OHIO TURNPIKE AND INFRASTRUCTURE COMMISSION

ADDENDUM NO. 1

**PROJECT NO. 43-17-04
BRIDGE DECK REPAIR AND BRIDGE REMOVAL
OHIO TURNPIKE OVER QUARRY ROAD, M.P. 138.0
OHIO TURNPIKE OVER INACTIVE RAILROAD, M.P. 138.2
LORAIN COUNTY, OHIO**

ANSWERS TO QUESTIONS RECEIVED THROUGH 10:00 AM ON NOVEMBER 22, 2017

STANDARD DRAWING CB-4

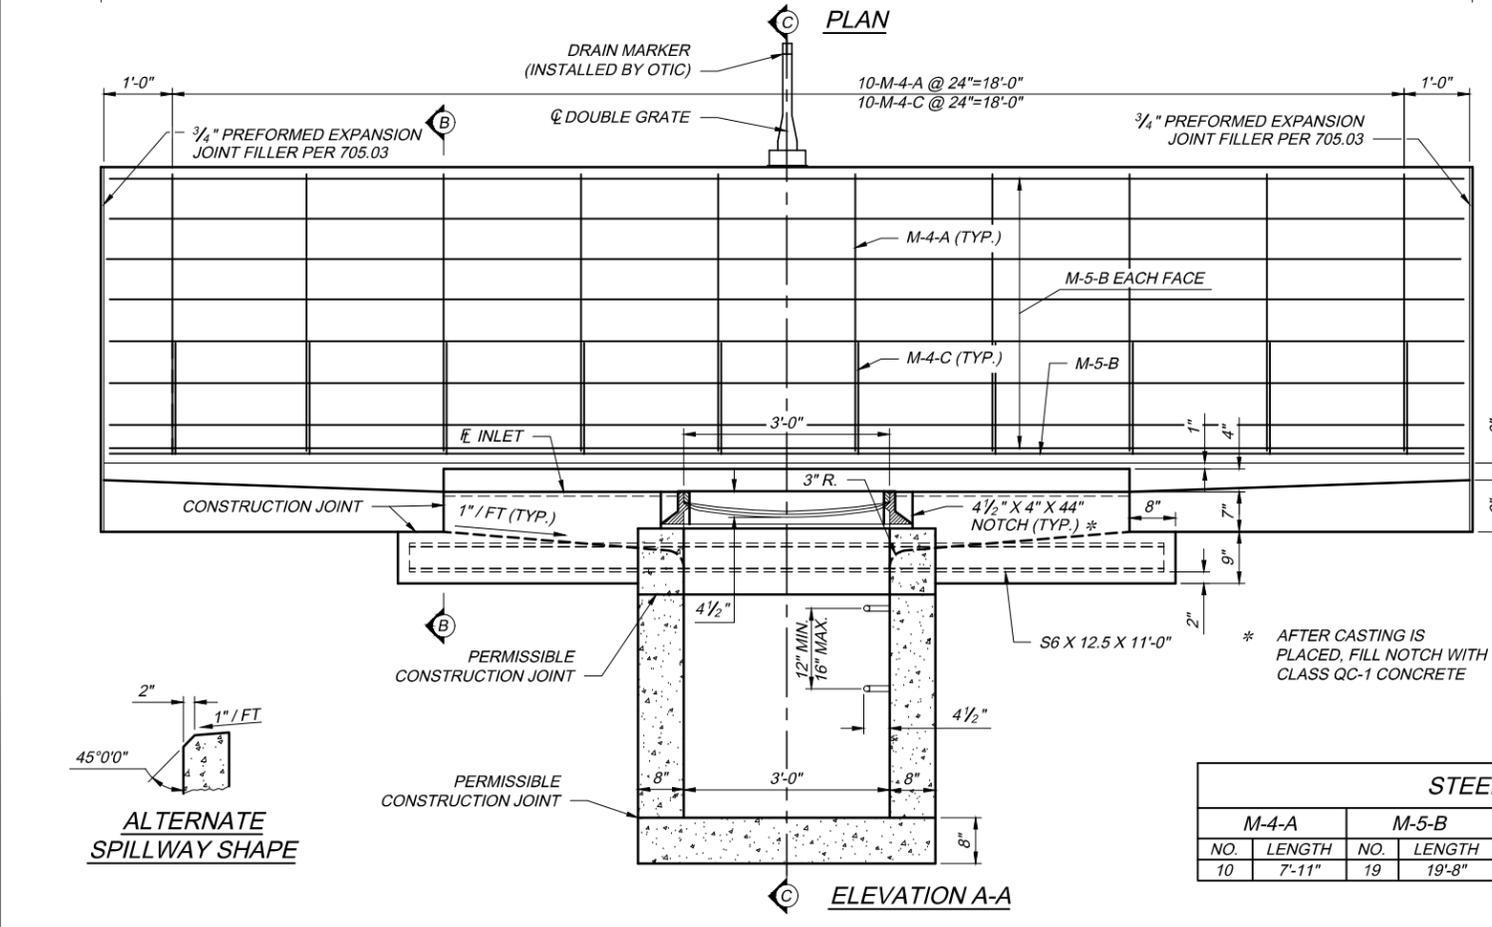
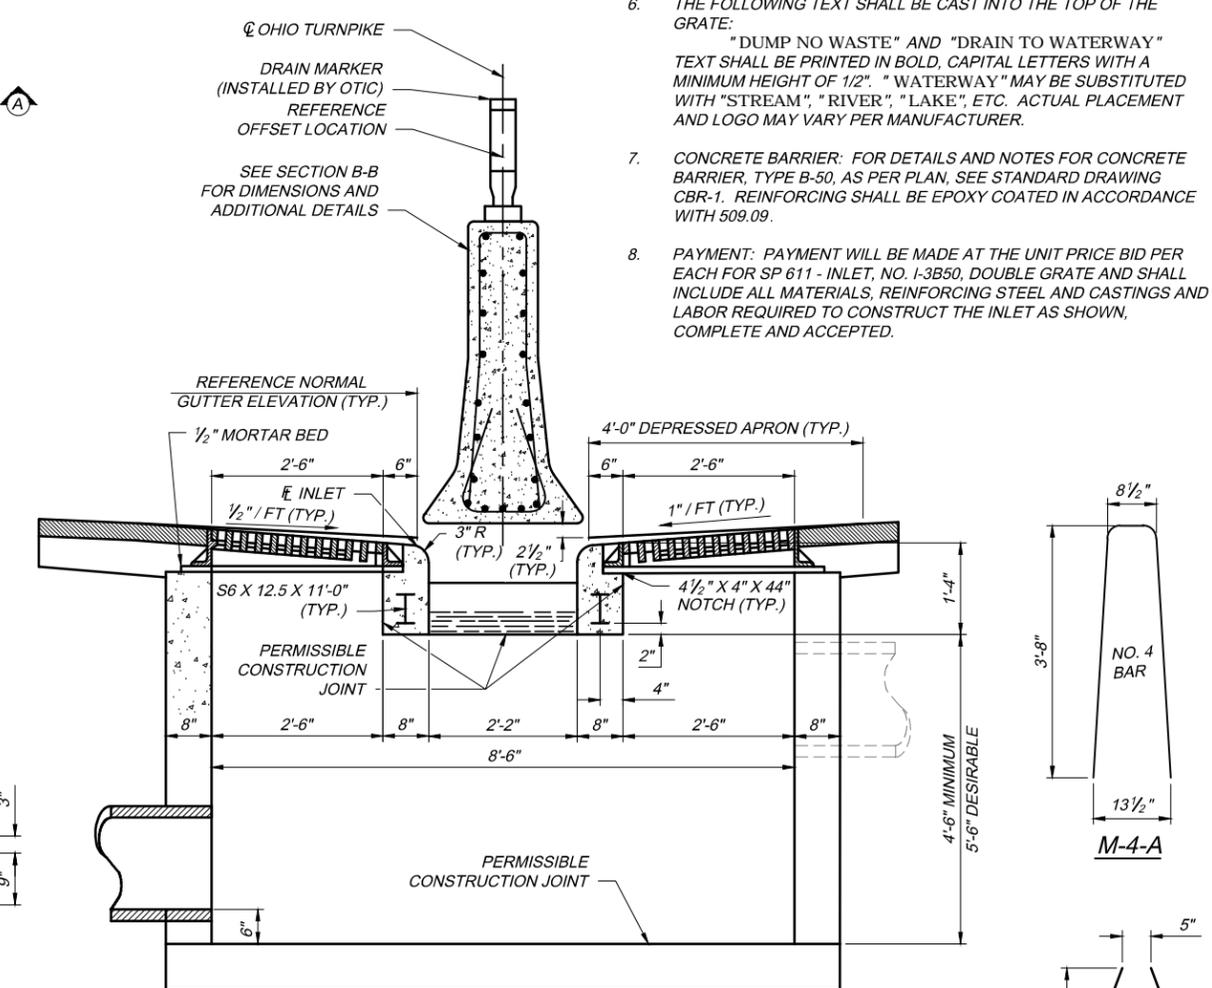
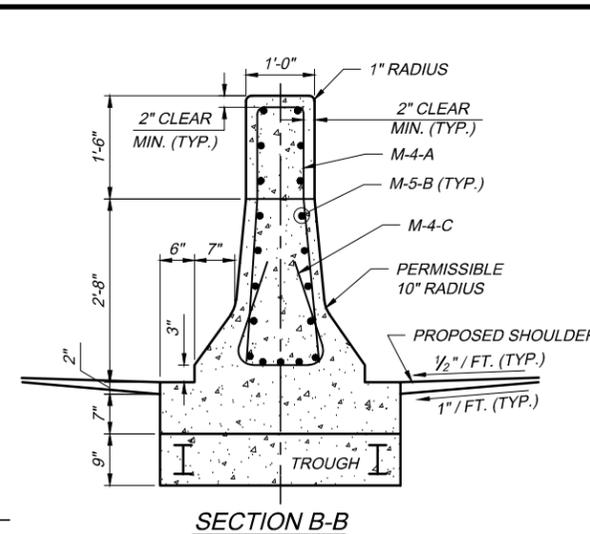
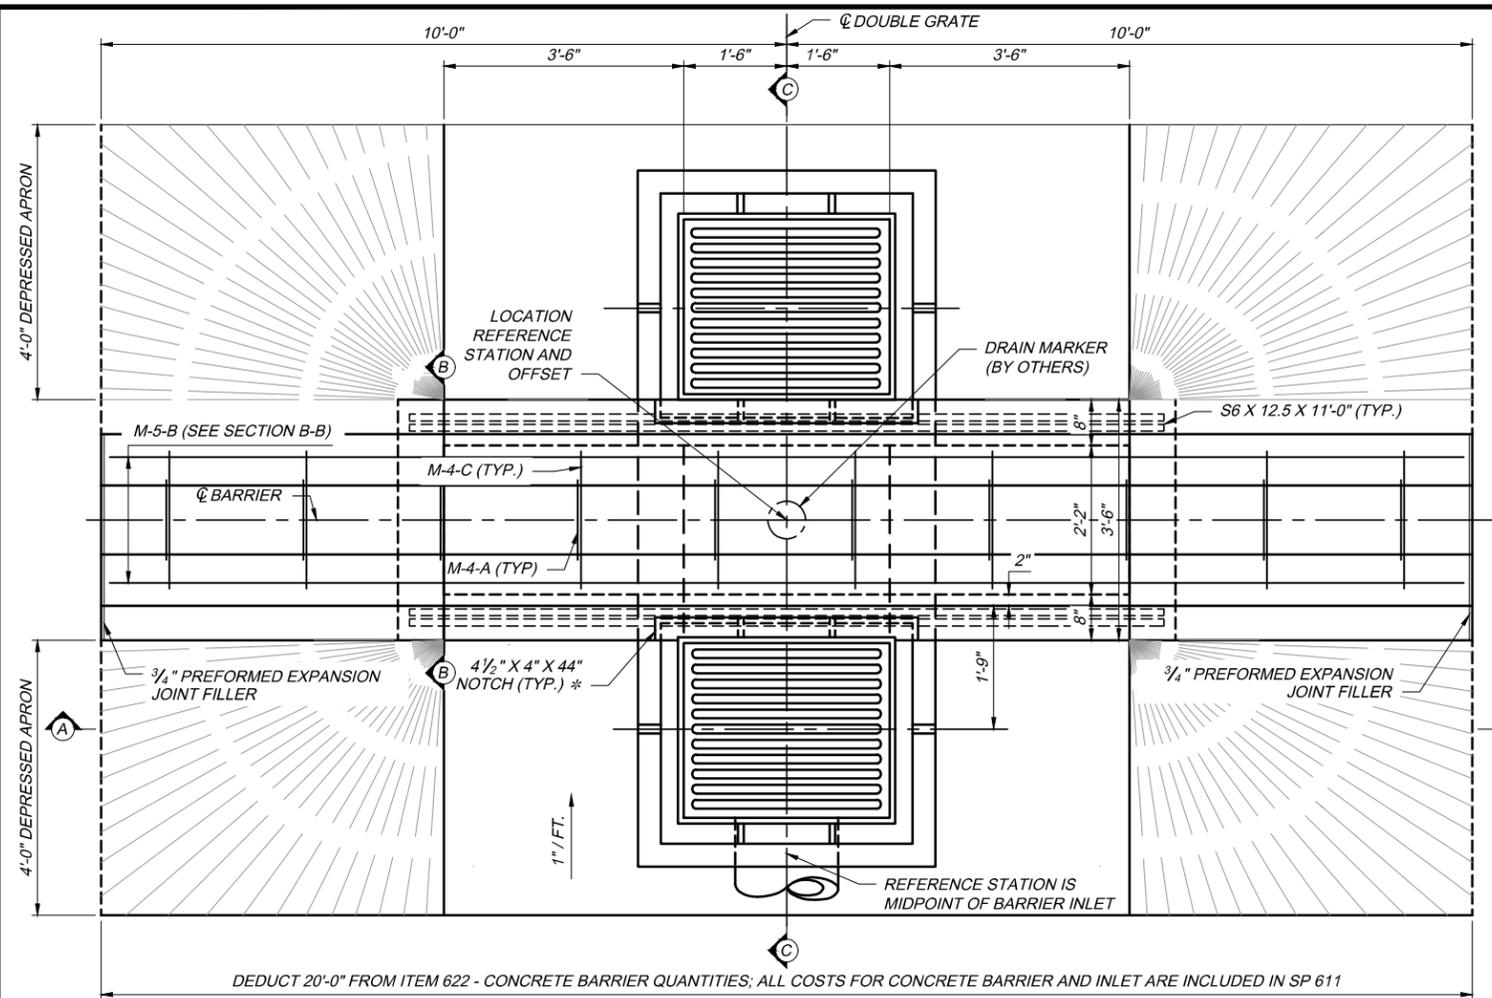
Q#2 Will the Concrete Barrier, Type B-50, As Per Plan be measured and paid through the inlet at approximately 294+60? Also, is additional reinforcing steel required in the 20 ft of wall at the inlet? If additional reinforcing steel is required, please provide appropriate standard drawings.

A#2 The median wall at approximate STA 294+60 shall be paid for as SP 604 – Inlet, No. I-3B50 as shown on OTIC Standard Drawing CB-4. Standard Drawing CB-4 has been added to the plan set.
